ISLAND AVE., PEAKS ISLAND

C7-2-2

Alterations - Island Ave. Peaks - Chambers 87-9-2  
 Millions of Dollars, minus Budget to Westside

AP - Island Avenue, Peaks Island  
Assessors' Lot No. 87-2-2

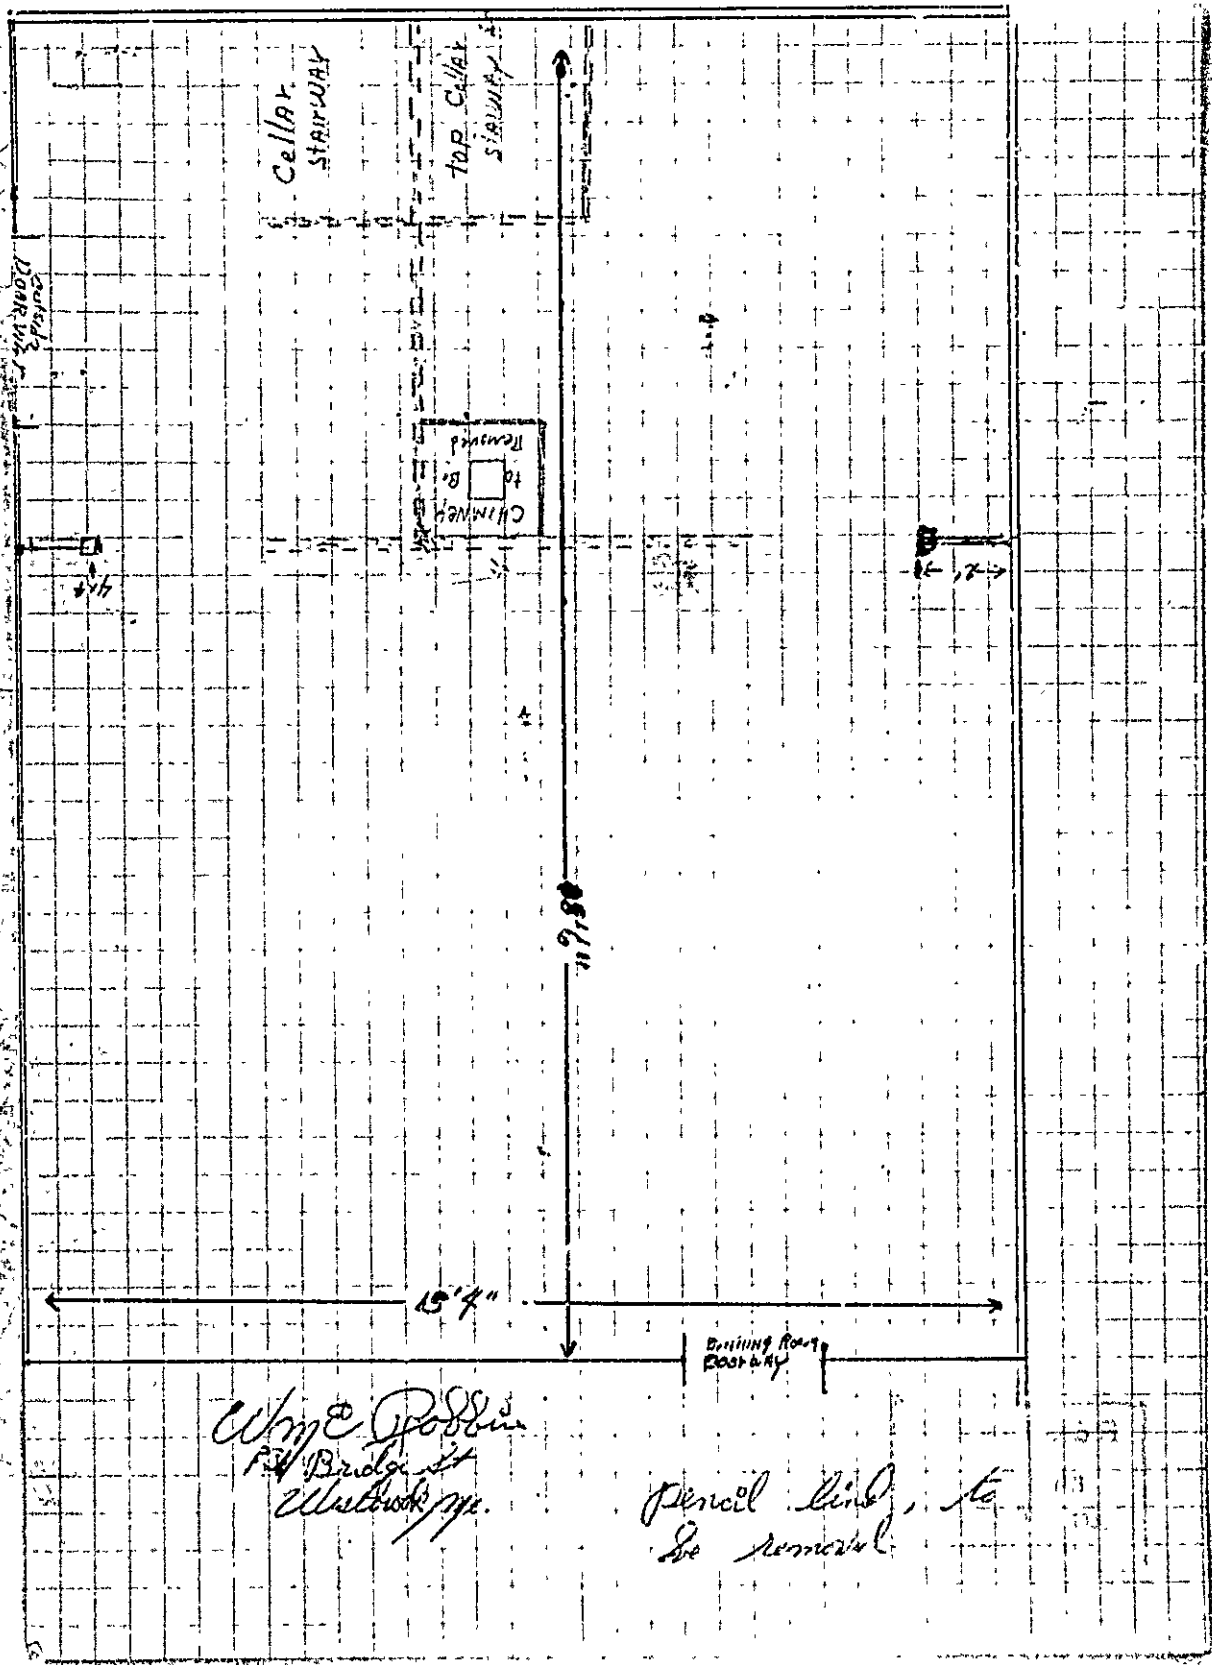
→ 2nd floor 2x6 - 24' o.c. 15' 1/2"  
 2nd floor for 7' 2x12 down  
 1st floor opening 11"  
 → 11' 2x6 - 22' o.c. 11"  
 ← 10' 6" 15' 4" →

Pencil lines to  
be removed

General for new bearing partitions

Partitions and floor on 15'-6" span at 0.5  
 good for 406 # in  $\frac{406}{31} = 14 \#$

Mr. Atkins is to cut span to 9' where front  
 floor partition is to be removed, so that  
 present 15'-6" span = 698" or  $\frac{698}{18} = 38 \#$

First floor partition at right angles to floor joists to be  
 removed, carrier = lbrs.

Hemlock 4" x 7" span = 3560  
 Total D.L. = 2163  
 Total Allowable L.L. = 1397

Use 4" x 8" hemlock 9' span good for 3560 #  
 2.7 # L.L.

First floor partition 9' long  
 to be removed (3' return) - 12' with floor joists  
 Second floor - 9 x 8 x 12 = 864  
 Part. - 9 x 8 - (2 x 8) 18 = 864  
 Ceiling - 9 x 8 x 10 = 720  
 40 = 1260 D.L.

Use D.F. 4" x 10" 9' span good for 6055 #
